**FINAL  
PHASE II (a) FIELD SAMPLING PLAN FOR  
TRENCHES, PITS, EXCAVATIONS, BUNKERS, FORMER  
BUILDINGS, AND GROUND SCARS**

**OF THE  
CAMP EDWARDS IMPACT AREA  
GROUNDWATER QUALITY STUDY**

**MASSACHUSETTS MILITARY RESERVATION  
CAPE COD, MASSACHUSETTS**

## Attachment A. Regulatory Agency Comments and Responses on Draft Trenches FSP

Figure 3. Locations of Trenches, Ground Scars, Excavations, and Bunkers with 1966 photo

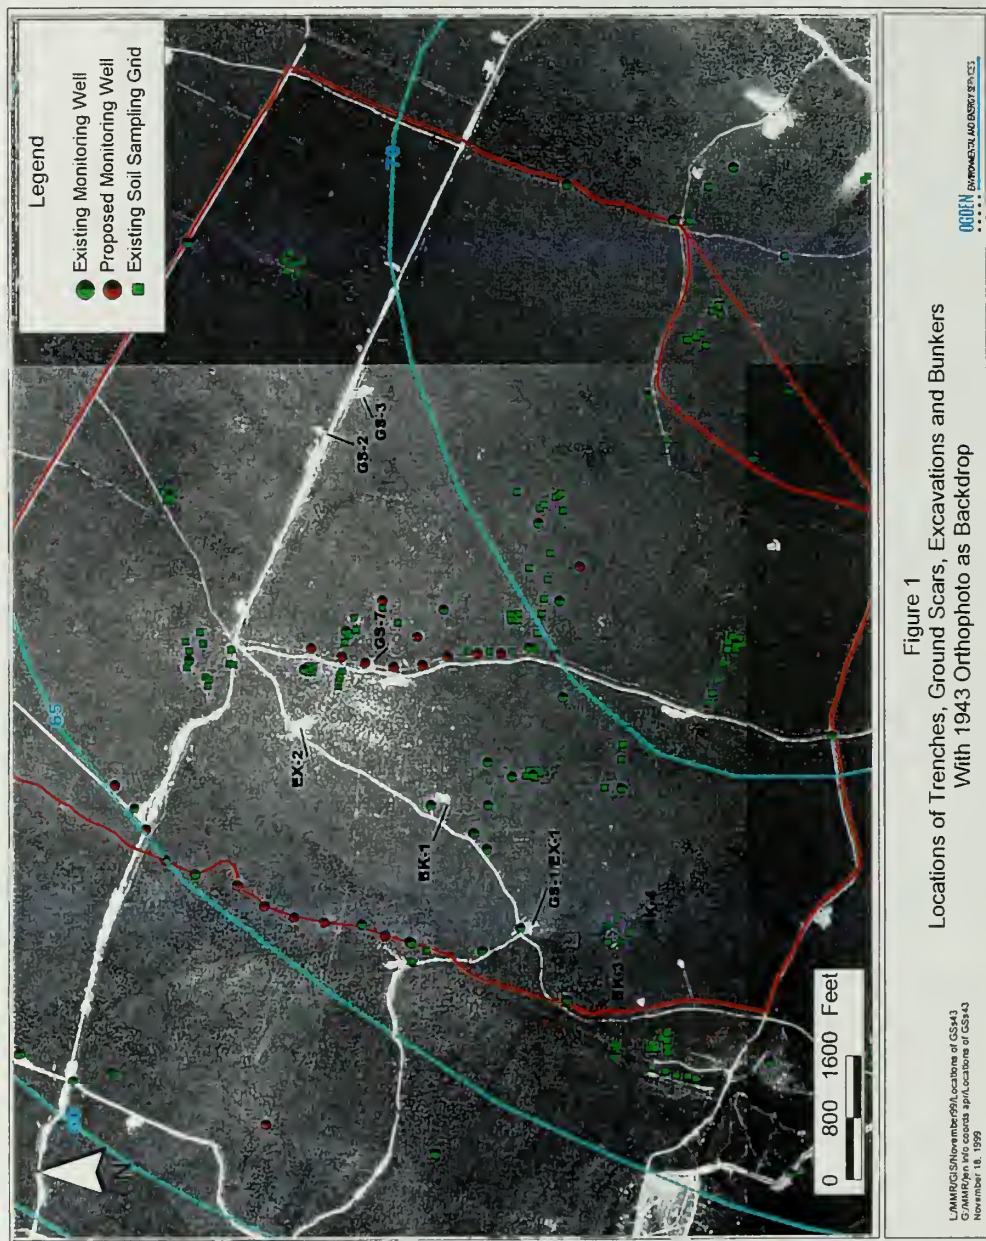
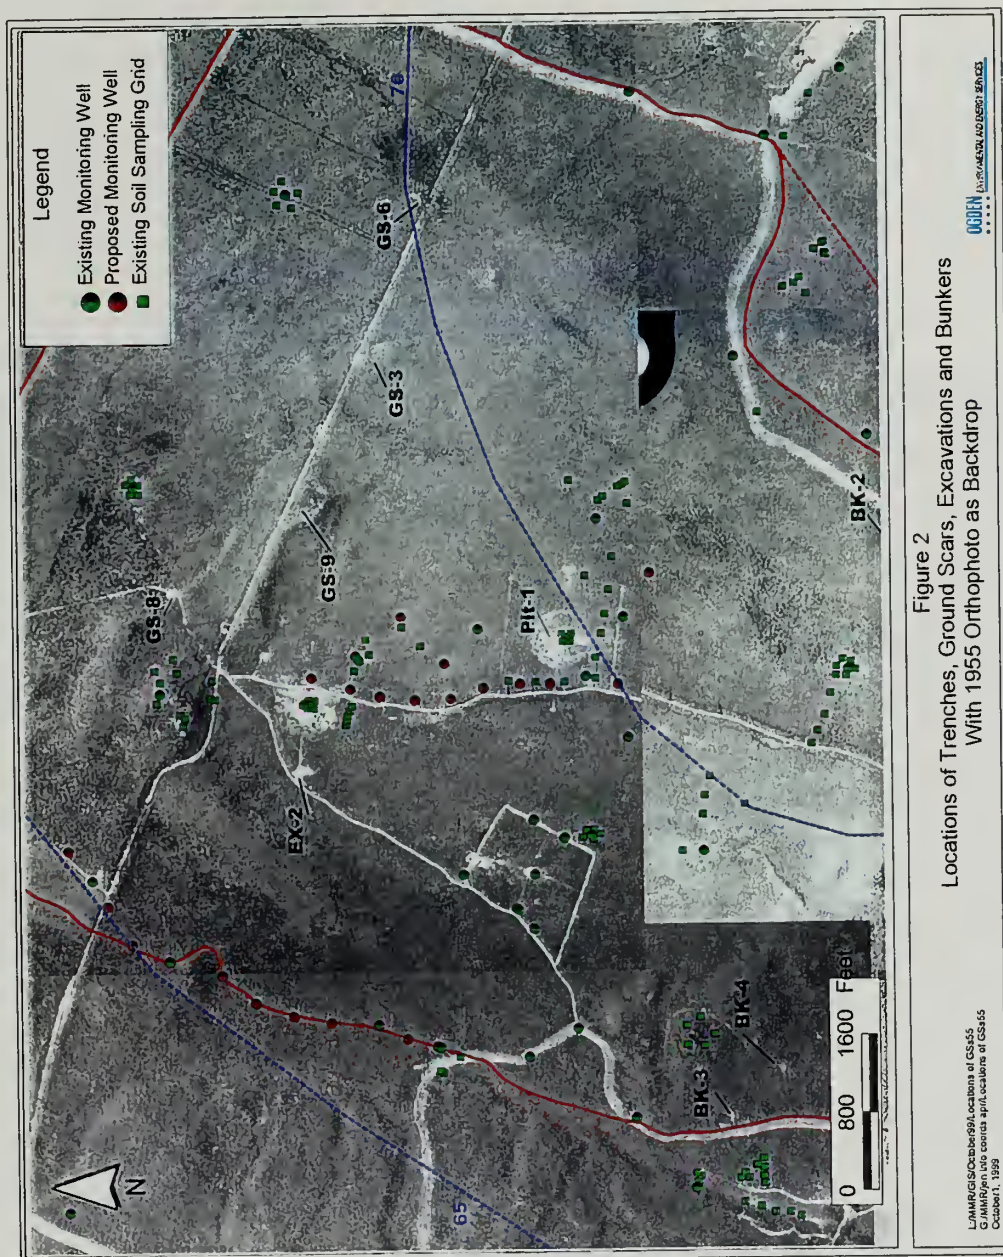
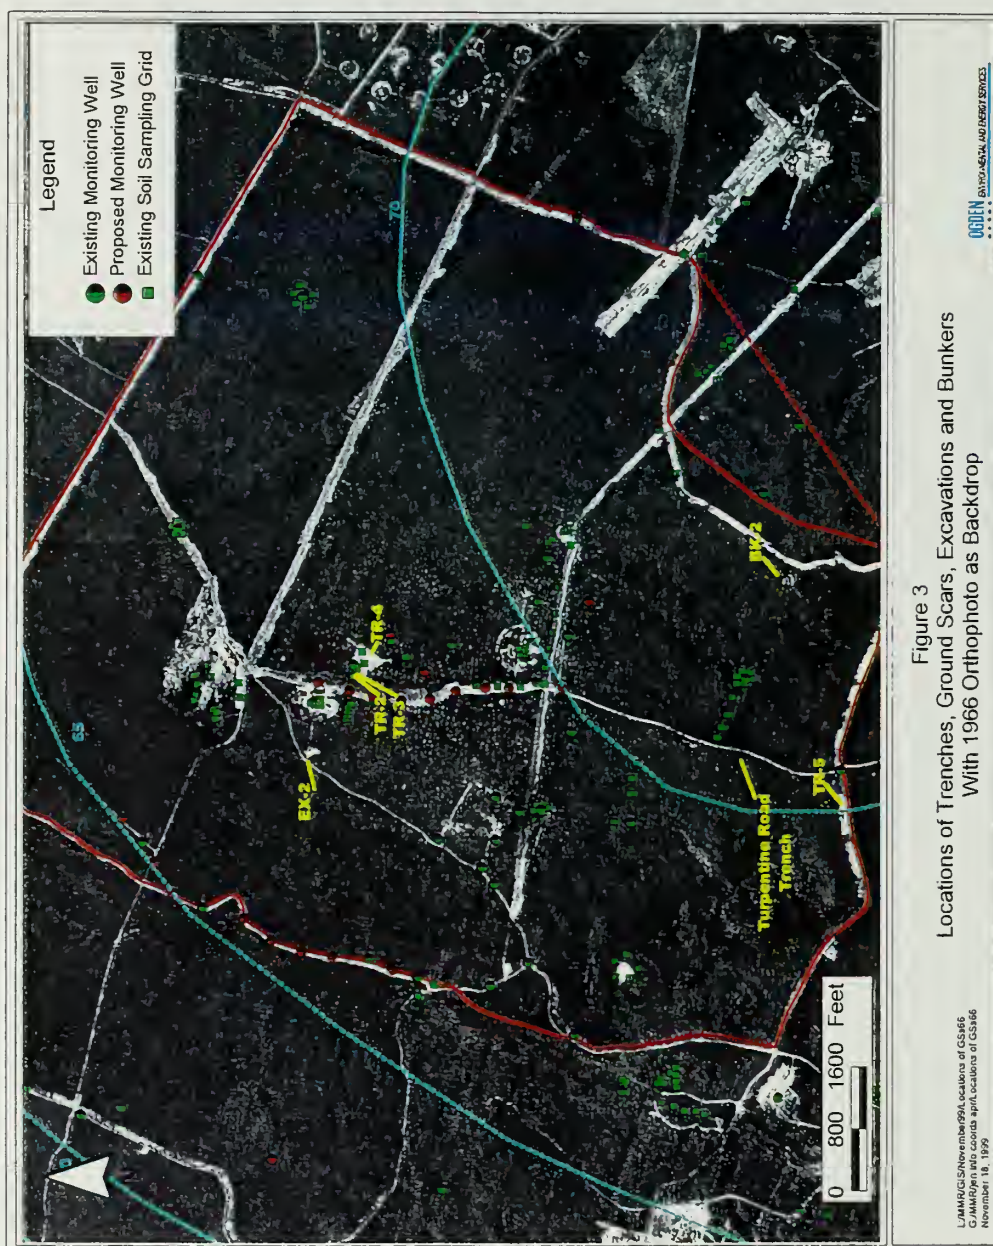
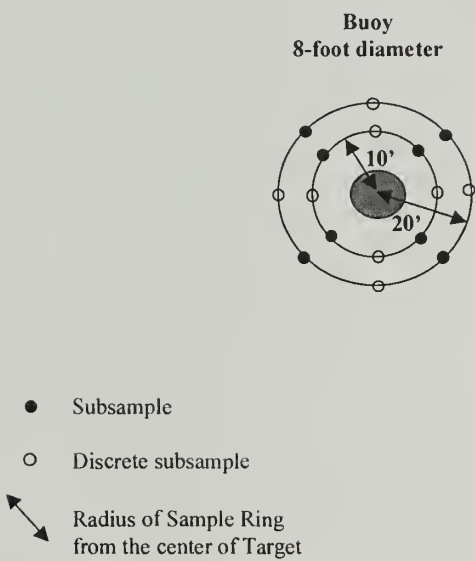
3. Page 6, Section 1.1.14 -- For TR-5, the approximate location should be indicated on either Figure 2 or 3, as appropriate.

5. Pages 11-13, Figures 1-3 – Please indicate the location of BK-1 and the cleared area to the immediate south of BK-1 which are to be sampled as part of this plan.

### **3. Page 11, 12, and 13: Figures 1, 2, and 3 ... Locations of Ground Scars, Excavations and Bunkers... (1943, 1955, and 1966 Orthophoto as Backdrop, respectively)**

Each of these Figures includes symbols that are identified as locations of **“Proposed Monitoring Wells”** in the Legend. Although these wells are not referenced in the text of the FSP, the Department assumes they represent the well locations proposed in the NGB’s September 23, 1999 document entitled **“Phase II (a) Response Plan for Impact Area RDX Detections in Groundwater”** (the “RDX Response Plan”). It is the Department’s understanding that the locations of the RDX Response Plan wells have not been finalized. Please revise the text and/or figures of the FSP to clarify the purpose of the proposed wells shown on these three figures.

*The figure will be revised as requested.*

*The location of the cleared area at BK-1 has been labeled on Figure 1. The location of the Turpentine Road trench (see specific comment 4) has been added on Figure 3.*

*The text will be revised as requested.*

Figure 7. Proposed Soil Investigation at BK-1.

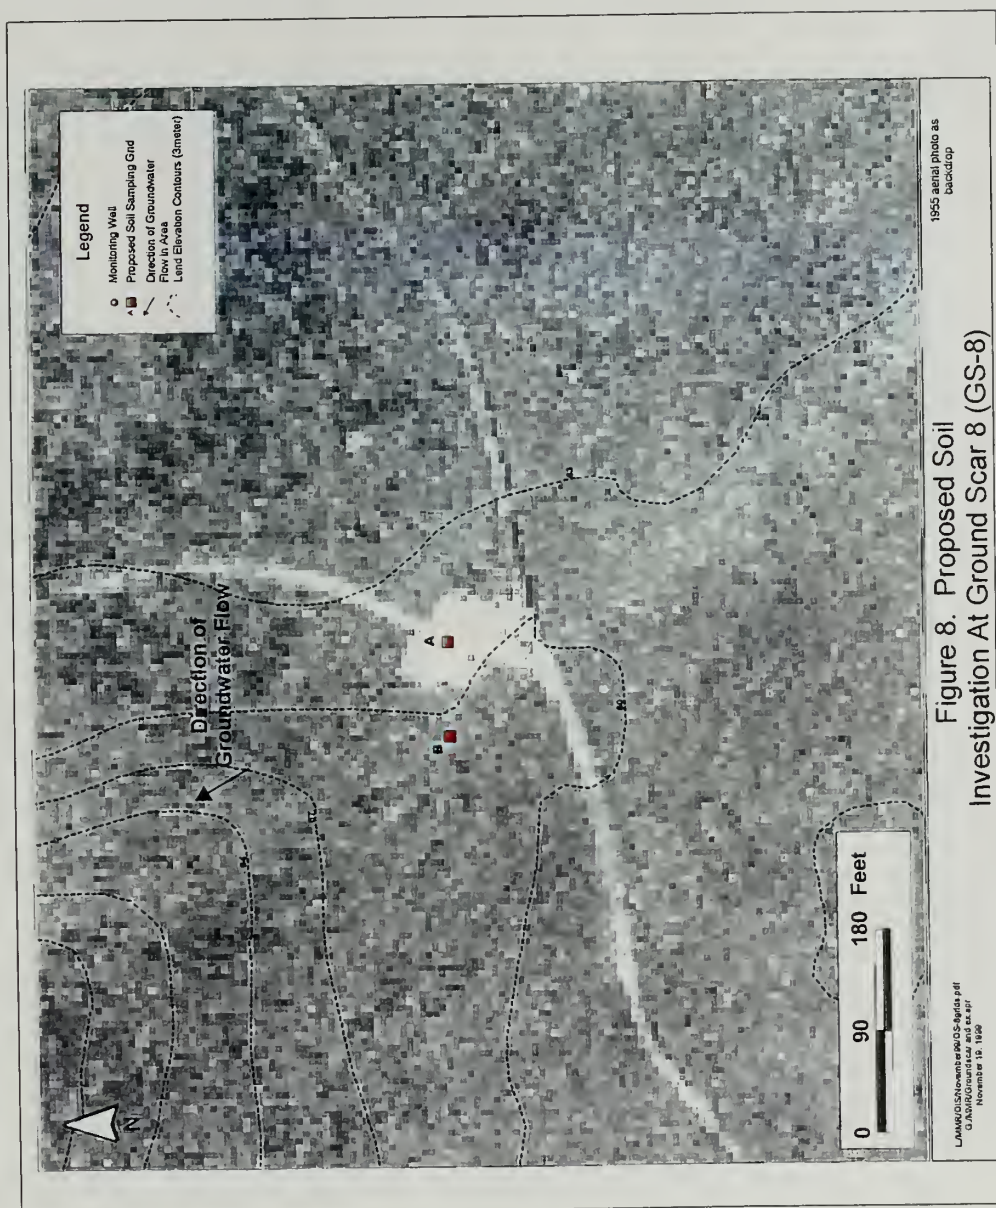
1. As discussed during the 28 October 1999 weekly IAGS Technical Meeting, the bunker referred to in this work plan as BK-1, is to be investigated by NGB as part of the IAGS, and not AFCEE as part of the Installation Restoration Program (IRP). In addition, EPA requests NGB investigate and sample a cleared area approximately 100 feet south of BK-1, evident in the 1955 and 1966 aerial photographs. This investigation is to include, at a minimum, UXO clearance of BK-1 and the immediate area, UXO clearance of the cleared area observed in 1955 and 1966 aerial photographs, and at least one soil sampling grid at each of these locations. Since these locations appear to have been disturbed previously, soil samples should be collected from five-point grids at 0 to 6 inch, and 18 to 24 inch depths (as is currently planned for soil sampling at the Gun and Mortar positions). If BK-1 contains a dirt floor, at least one (1) discrete soil sample is to be collected from inside this bunker.

7. Page 16 – Please update the figures section to include all of the locations requested above.

*Change pages to show the additional investigations at the bunker and the cleared area south of the bunker were provided to the regulatory agencies on 11/18/99. Section 2.2 will be revised to indicate the change in sampling depths.*

*New Figures 7, 8, and 9 have been inserted to show the position of soil sampling grids in*

*the cleared area south of BK-1, at GS-8, and at Pit-1, respectively. Existing Figure 7 has been relabeled Figure 10.*

Figure 9. Proposed Soil Investigation At Pit 1

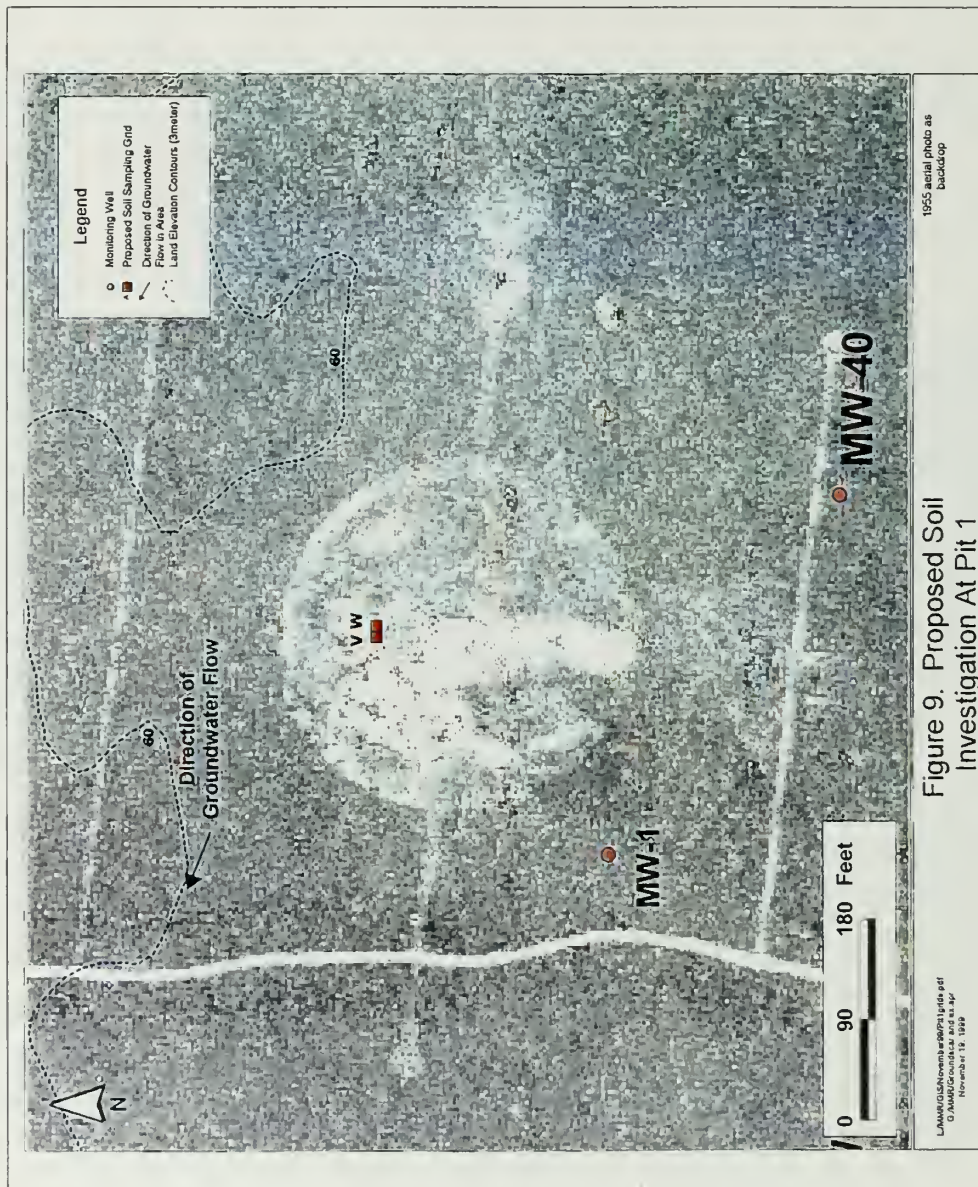
2. Page 5, Pit-1 (Photo 13) – EPA requests that this former pit be sampled, based on historical aerial photographs and the current heavily cratered and training-round littered topography. EPA requests a minimum of two (2) grids be established at this location.

*The suggested investigations will be added. Two grids will be located within the former circular cleared area at the location identified as a “possible pit” based on aerial photo*

*analysis. No pit was observed in this area during the August 1999 reconnaissance. The Guard will conduct additional reconnaissance of this area by helicopter in December 1999. If no pit is observed from the airborne reconnaissance, the two grids will be placed adjacent to each other at the location indicated by the photograph. The former circular cleared area was characterized as part of Area 3 in Phase I of the IAGS.*
